# Access Compliance Report

## Public Rights-of-Way

### (Curb Ramps)

Intersection ID: 11457	Main Street: TRYON-CHURCH_CONNECTOR_ST	Cross Street: N_CHURCH_ST	Location: E
ADA ID: 3B10FFF06E9E	Ramp Type: Para	Initial Pass/Fail: Pass	Overall Compliance: No
Severity Score: 0.25			
Codes/Mitigation Info/Possible Solution		Field Measurements/Component Compliance

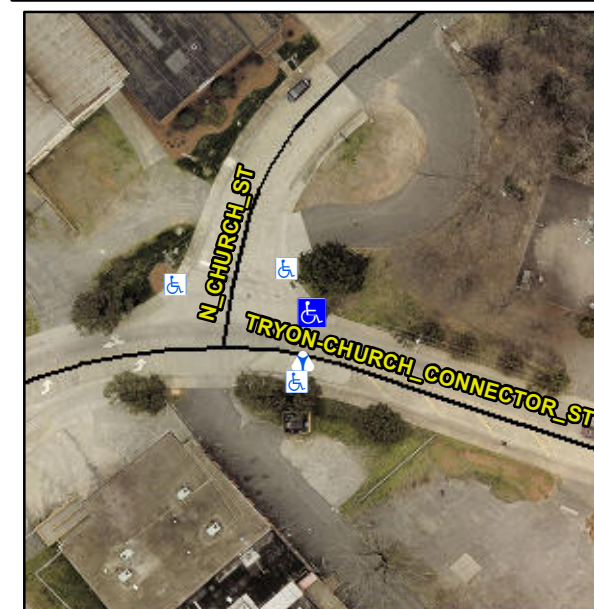
**RT RP < 5%**

**Not Found, R304.5.3, R304.2.1**

Compliance	Description	Data	Compliance	Description	Data
N/A	Ramp Length LT (in)	62.0	N/A	Ramp Length RT (in)	64.0
Yes	Ramp Width LT (in)	60.0	Yes	Ramp Width RT (in)	59.5
Yes	Ramp Slope LT (%)	7.7	Yes	Ramp Slope RT (%)	2.6
Yes	Ramp XSlope LT (%)	0.6	No	Ramp XSlope RT (%)	2.5
Yes	Landing Length (in)	60.0	Yes	DWS Provided?	Yes
No	Landing Width (in)	47.5	Yes	DWS Contrast?	Yes
Yes	Landing Slope (%)	0.8	Yes	DWS Length (in)	24.0
Yes	Landing X Slope (%)	2.0	Yes	DWS Full Width?	Yes
N/A	Landing Curb? (Y/N)	No	Yes	DWS Offset (in)	0.0
N/A	Shared Landing?	No			
Yes	Gutter Ponding?	No	Yes	Gutter Slope (%)	3.3
Yes	Gutter Lip Ht (in)	0.0	No	Gutter X Slope (%)	4.0
N/A	Painted X Walk1?	No	N/A	Painted X Walk2?	N/A
	X Walk 1 Direction	To S		X Walk 2 Direction	N/A
N/A	X Walk 1 Width (in)	N/A	N/A	X Walk 2 Width (in)	N/A
	X Walk 1 Slope (%)	2.6		X Walk 2 Slope (%)	N/A
	X Walk 1 X Slope (%)	1.1		X Walk 2 X Slope (%)	N/A
N/A	Ramp inside XWalk1?	N/A	N/A	Ramp inside XWalk2?	N/A

Road Slope (%)	N/A	N/A	Clear Space?	Yes
	Road X Slope (%)	N/A	N/A	Clear Space to XWalk (in)	N/A
Yes	Any Obstructions?	No	Yes	Storm Grate/Utility Hazard?	No
	Obstruction Type			Storm Grate/Utility Type	
		N/A			N/A
			Yes	Surface Condition? (G/P)	Good
			Replace	Curb Slope (%)	17.3

**Remove & Replace Entire Ramp.**  
**Remove & Replace Gutter.**
